TT7780EN
March, 2016
Page 1 of 3

SUBJECT: PACCAR North American MY2016 Vehicles and Allison Electronic Service Tools

MODELS AFFECTED: 1000, 2000, 3000 and 4000 Series Product Family Transmissions

Figure 1. Tool Side and Connector Side

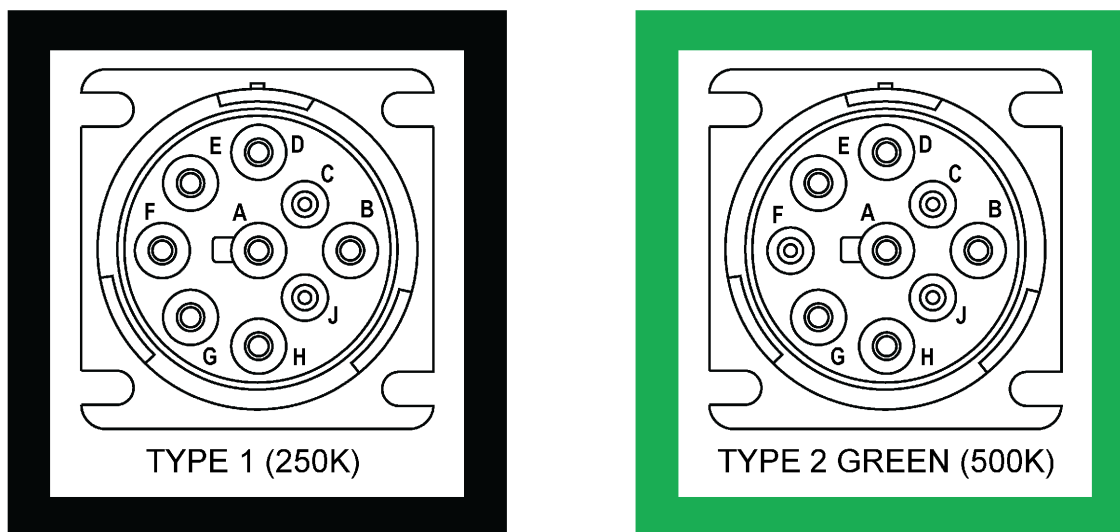
In model year 2016 vehicles manufactured for the North America market, PACCAR changed the SAE J1939-13 diagnostic connector type and pin locations for the vehicle controller area network (VCAN). Beginning in model year 2016, PACCAR vehicles are equipped with the green Type 2 SAE J1939-13 connector (refer to Figure 1). The PACCAR V-CAN and Allison transmission control module (TCM) is connected to pins F and G. PACCAR model year 2015 and earlier used the black Type 1 SAE J1939-13 connector with the V-CAN and TCM connected to pins C and D. Refer to [Figure 2](#) for pin locations differences between PACCAR's Type 1 and Type 2 diagnostic connector.

PACCAR released a pass-through cable part number 42-02848 known as "Cable, Y-adapter, DLA green" to allow communications with the Vehicle CAN and TCM. Authorized Allison service locations are approved to use PACCAR's adapter cable to connect with Allison Electronic Service Tools. The adapter cable may be obtained from a local Kenworth or Peterbilt dealer.

Figure 3. Check Physical Connections

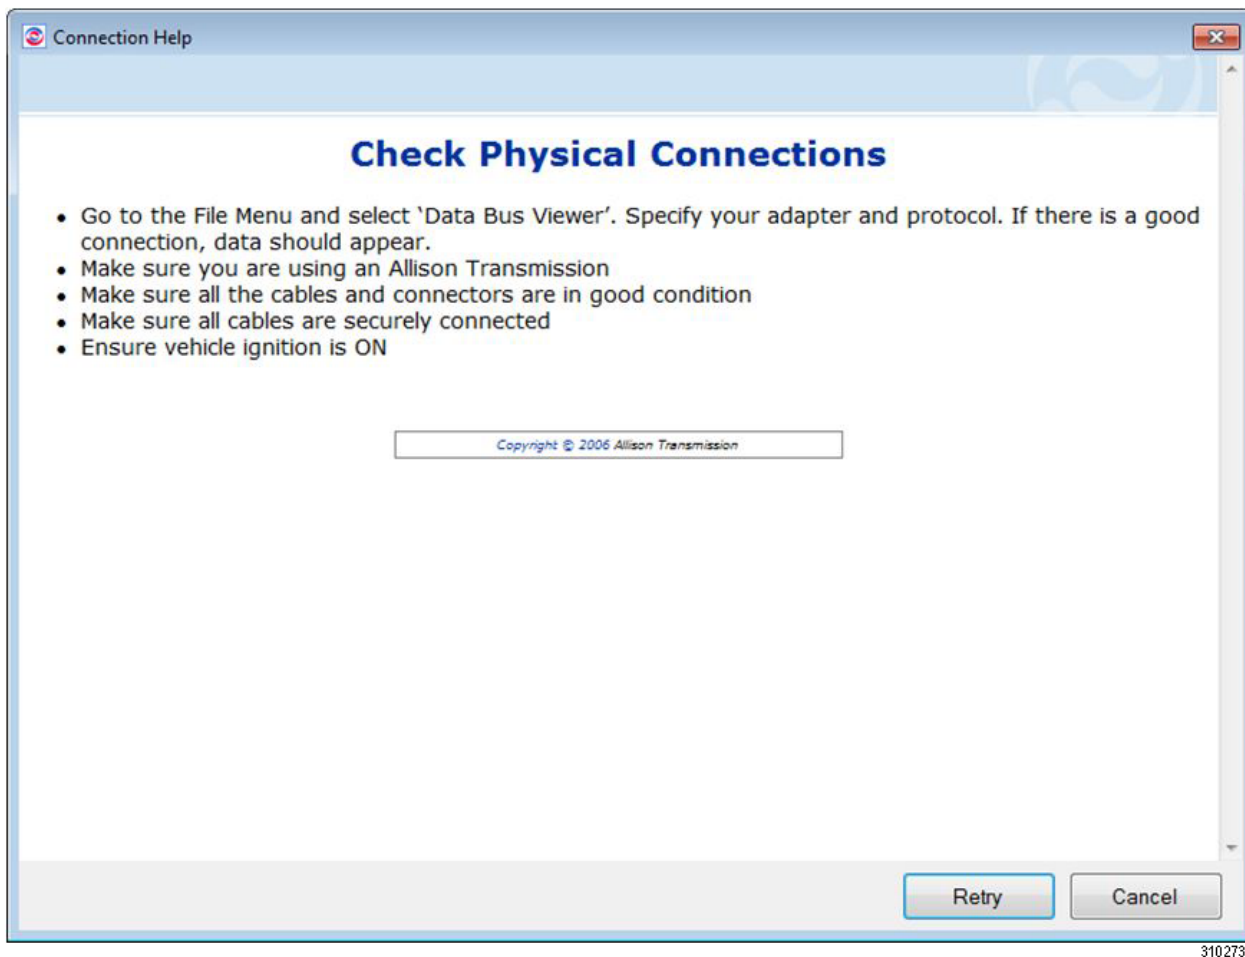
Allison electronic service tools (i.e. Universal Allison DOC® and Allison TCM Reflash™) cannot communicate with a TCM connected to pins F and G. Refer to [Figure 3](#) and [Figure 4](#) for examples of the warning screens that will occur when attempting to connect to a North American model year 2016 or later PACCAR vehicle.
